Ordinary Meeting of Council Agenda

11.2 Yarra Community Infrastructure (possible revised layout) - The Village, Alphington

1. This report provides an outline to Council of a '*possible revised layout*' by Alpha Nominees (the proponent) of some of the facilities in the major development site fronting Heidelberg Road. It is a conceptual plan at this point in time by the proponent.
2. The possible changes relate to the required community facilities to be provided (and vested) to the Yarra City Council, and also to the possible school campus, should the Victorian School Building Authority determine to proceed with a senior campus for the Alphington Primary School.
3. The report provides an outline of this concept and seeks some guidance from Council as to whether or not the concept is worth pursuing formally by Alpha Nominees via a formal statutory planning amendment process.

Attachment 2 - The Village Alphington Proposal 1

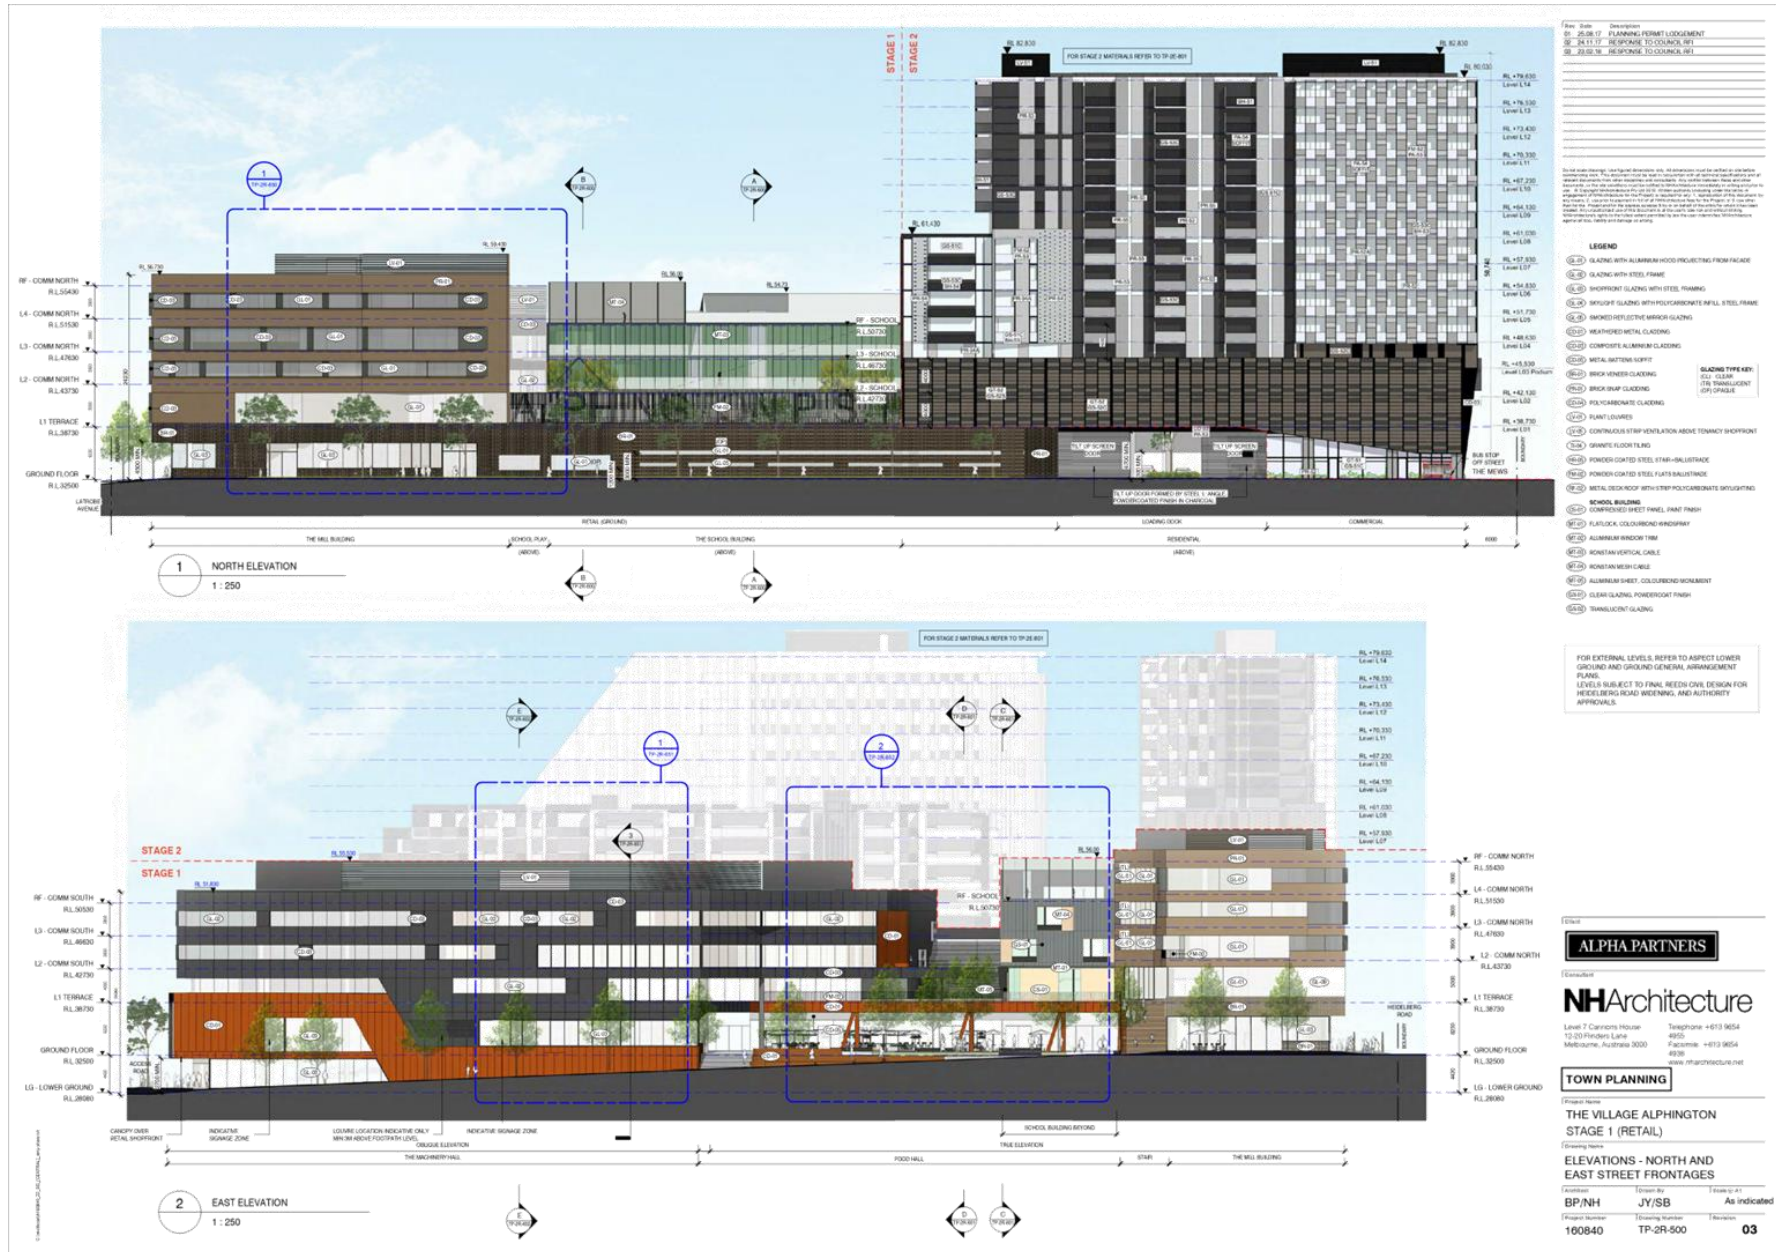
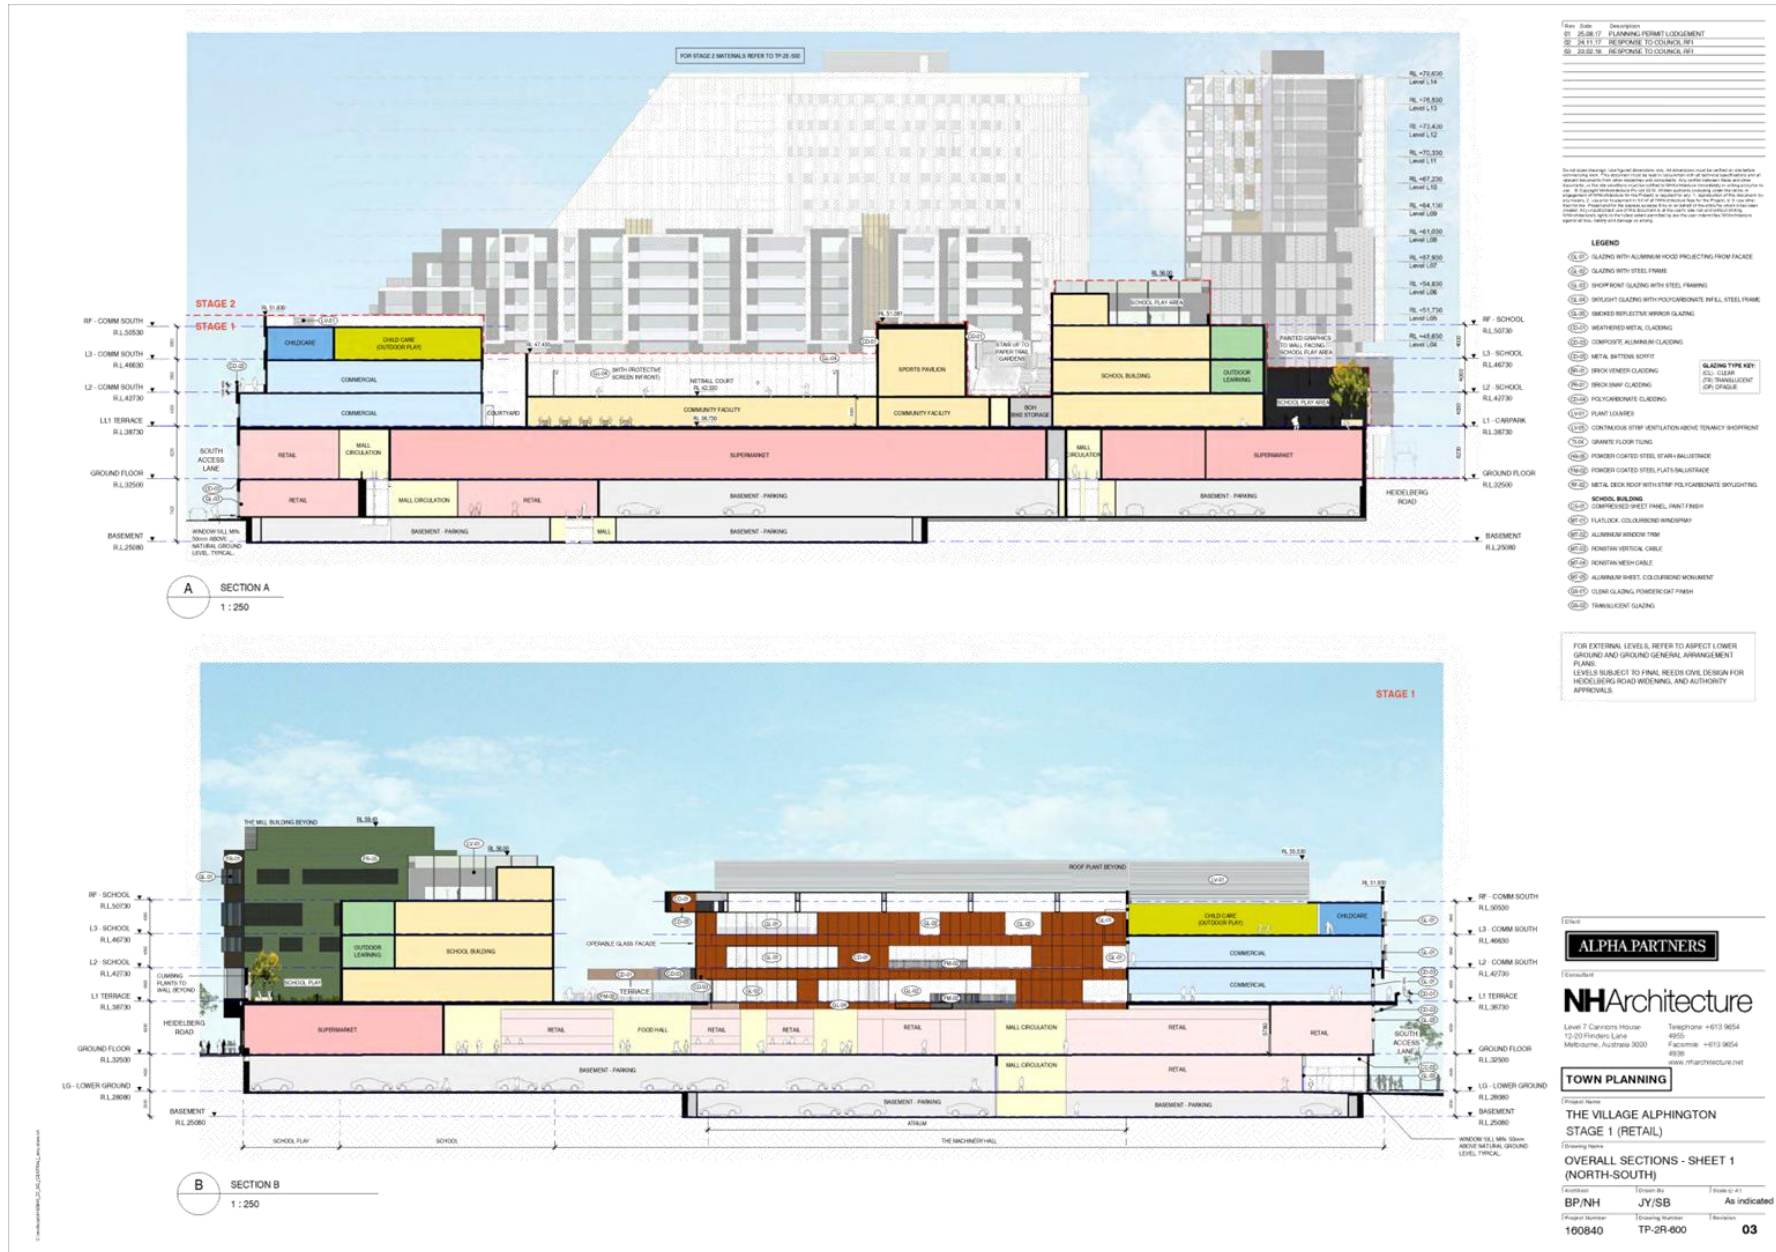
31. It is important to note, however, that there were deficiencies in Proposal 1 that need to be resolved for this proposal to reach a satisfactory built outcome. These concerns were expressed in the Council report on the planning application in June, 2018 regarding the layout and practicality of the community space insofar as concerns with columns, skylights and daylighting factors.

39. As said above, the 'performance' (adequacy in layout) of the community space in Proposal 1 (submitted with the planning application) contained some concerns and these were expressed to Council by officers with corresponding recommendations. The Planning Permit (issued on 5 June, 2018) contains requirements for amended plans to the satisfaction of the Responsible Authority (Council) to address those issues (see relevant conditions in Attachment 1).

Attachment 3 - Plans of Community Facilities/School (concept as shown in September 18 'possible revised layout' - referred to as Proposal 2)

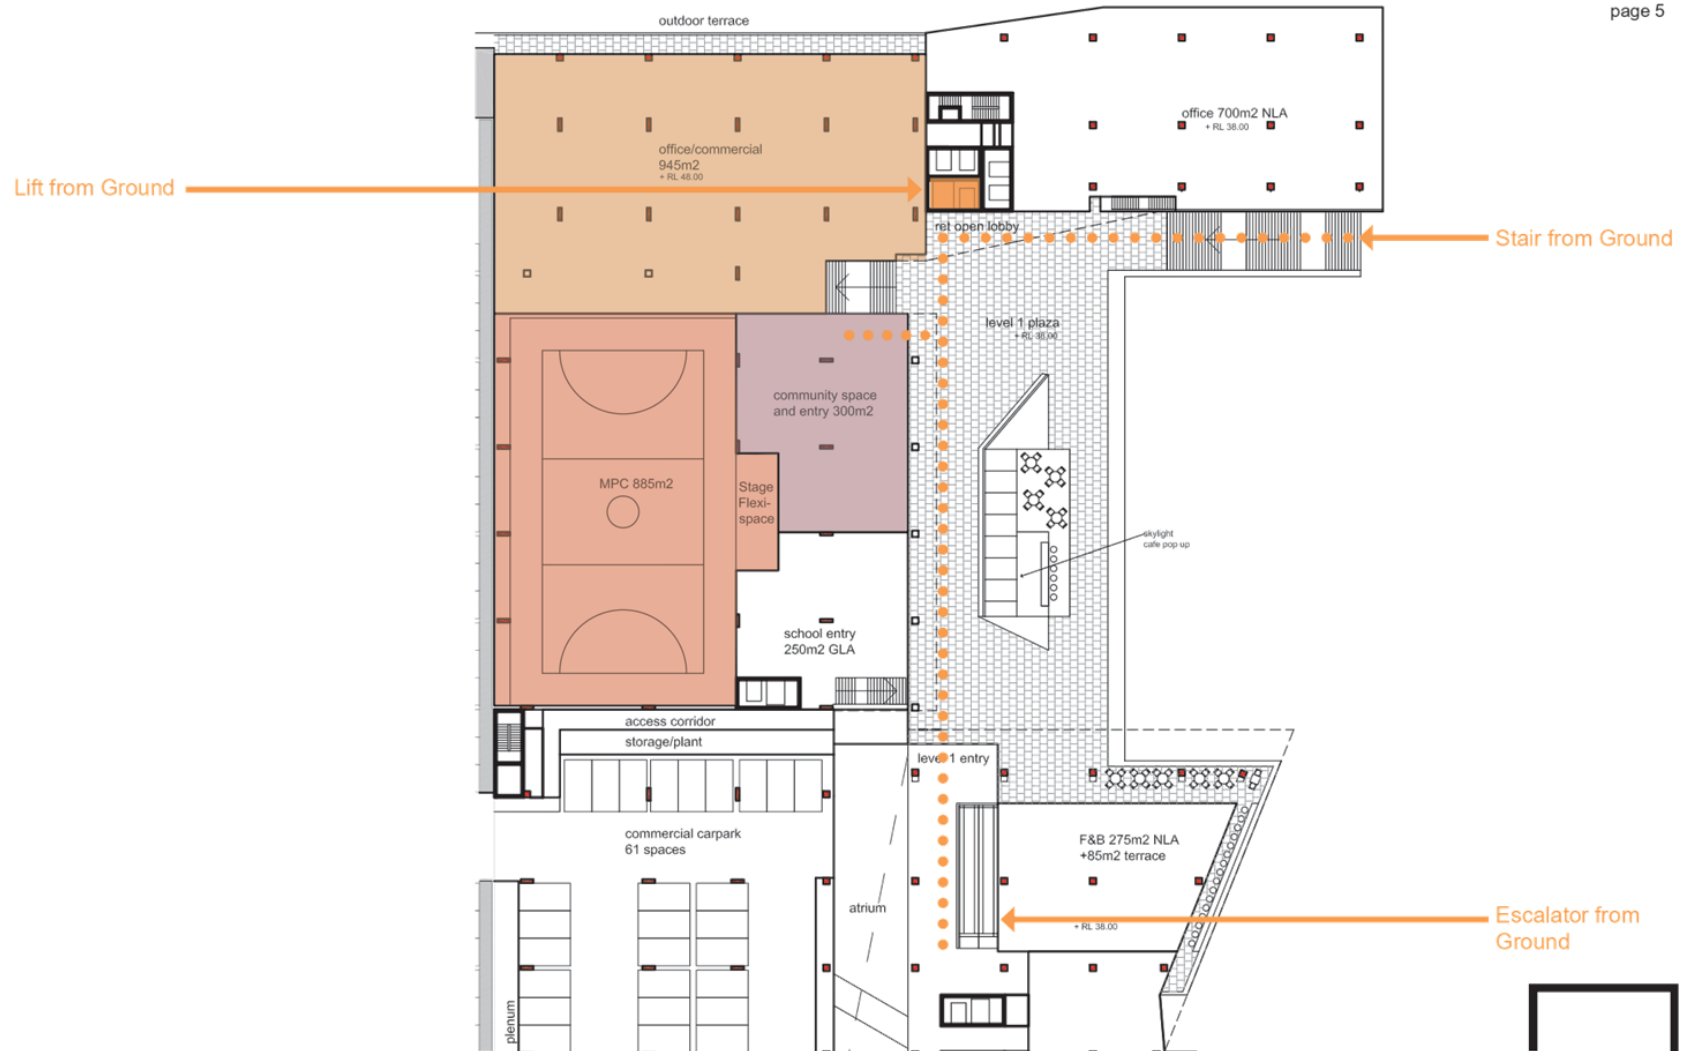
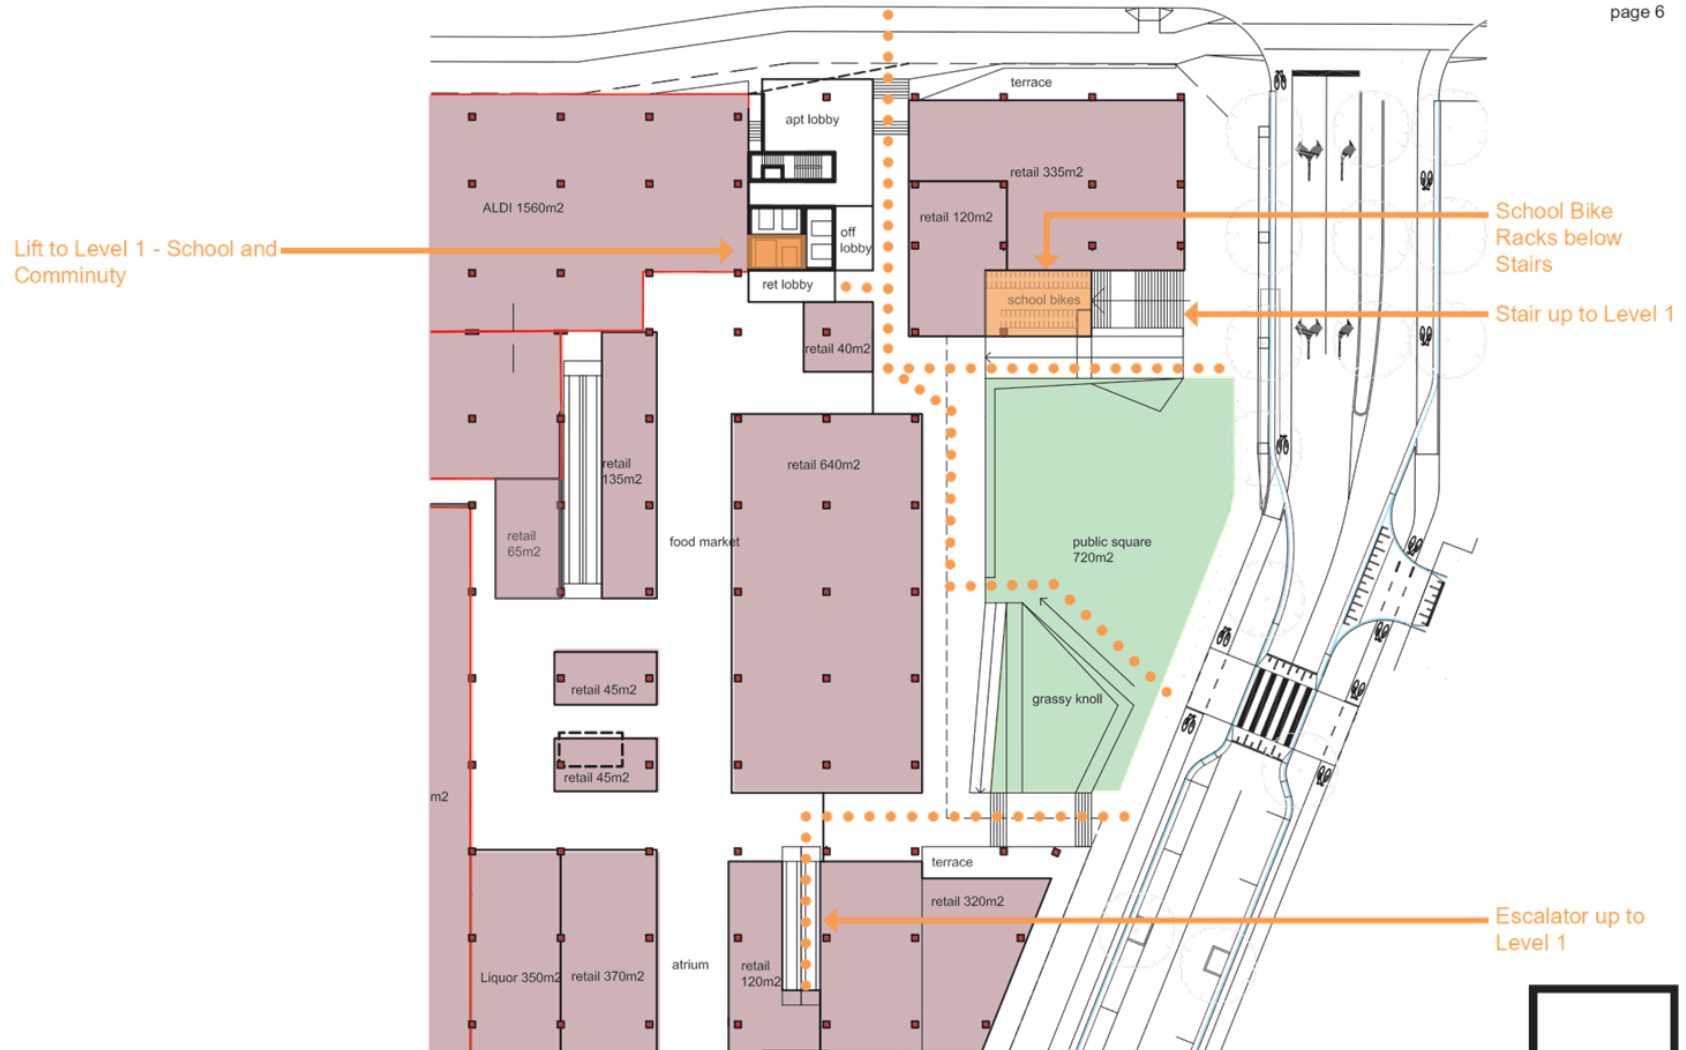
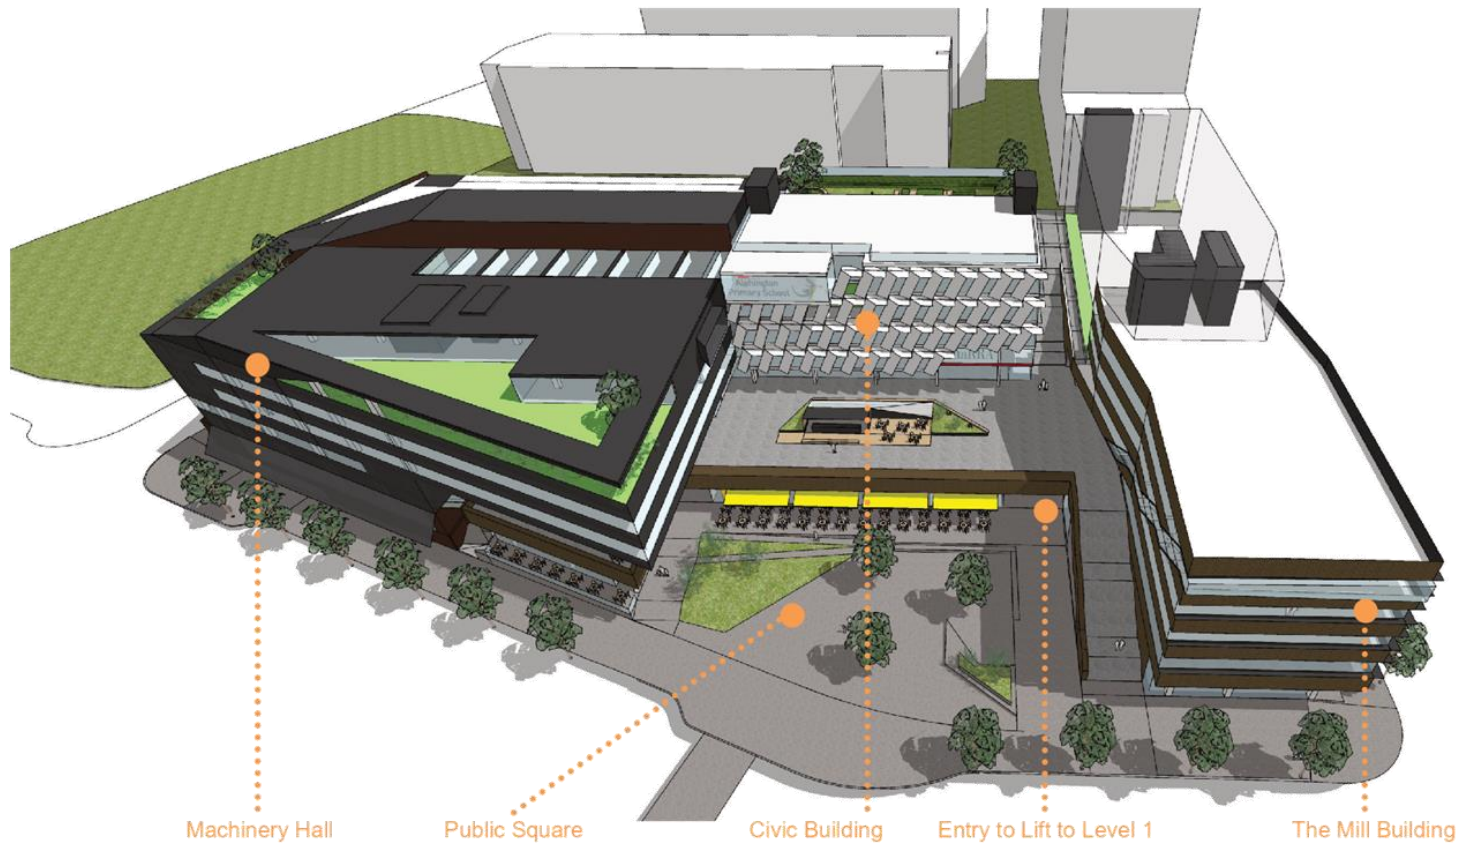
- (c) NB. It is noted that Proposal 2 does show a reduction in the overall floor area of community floorspace to be vested in Council through omitting the sports pavilion, decreasing the floor area of the 'warm shell' and decreasing the floor area of the fitted-out community space. *A detailed comparison and analysis are provided later in this report.*

32. Proposal 2 (possible revised layout) does not respond as well to the floor area requirements of the December 2015 resolution, however, this in itself does not necessarily present as a limitation if an overall better community outcome can be achieved from Proposal 2. It remains a Council judgement.

33. In order to provide functionality, such as independent bathrooms for the warm shell floorspace component and the community space, from the multi-purpose courts, and corridors to support independent access, the functional area for the community space and the warm shell have significantly reduced in Proposal 2.

41. There are some aspects of Proposal 2 that need to be carefully considered in Council forming an opinion on the possible revised concept. These include:

42. The forecourt to the new community space / school building needs to be appropriate for the abutting land uses. The forecourt in itself would be an asset and also provide a pleasant balcony to the plaza below and also as ‘break out’ space for both the community space and also the school. It is noted that the skylights proposed in the forecourt and the open air café are not considered conducive to the best use of that space.
